Informal Document GRSP-64-10
(64th GRSP, 11-14 December 2018,
agenda item 19)

**TSG R129.02 & R129.03 series
Approval Label Updates
Explanatory Notes
(GRSP-64-07 to GRSP-64-09)**

Approval mark for combinations

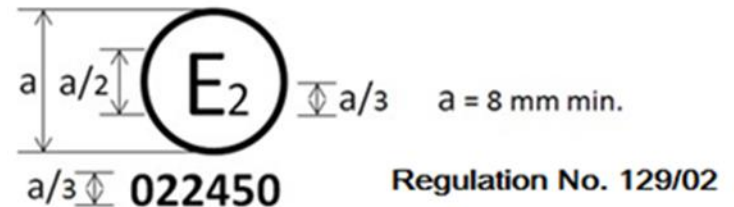
- Combining approval marks, to save space on the ECRS
- Modify shape of module label & include text dimension requirements, consistent with R129.03

$\frac{a}{3}$  i-Size Booster seat
 $\frac{a}{3}$  100 cm - 125 cm
 $\frac{a}{3}$  Specific Vehicle Booster seat
 $\frac{a}{3}$  125 cm - 150 cm

Approval mark for combinations

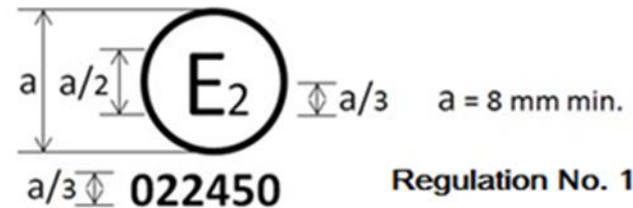
- Combining approval marks, to save space on the ECRS

$\frac{a}{3}$ i-Size Booster seat
 $\frac{a}{3}$ 100 cm - 125 cm
 $\frac{a}{3}$ Specific Vehicle Booster seat
 $\frac{a}{3}$ 125 cm - 150 cm

Approval mark correction

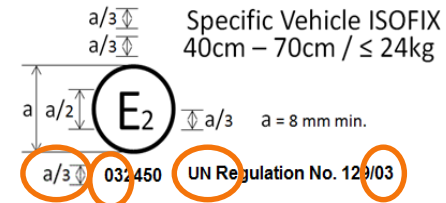
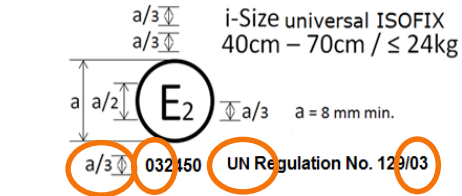
- Approval marks not updated to 03
- Approval number text size missing & “UN” missing

Approval mark & Module mark correction

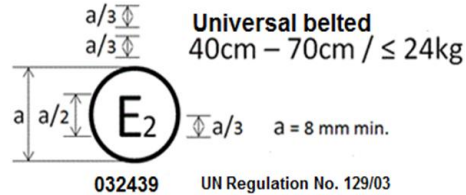
- Approval number text size missing
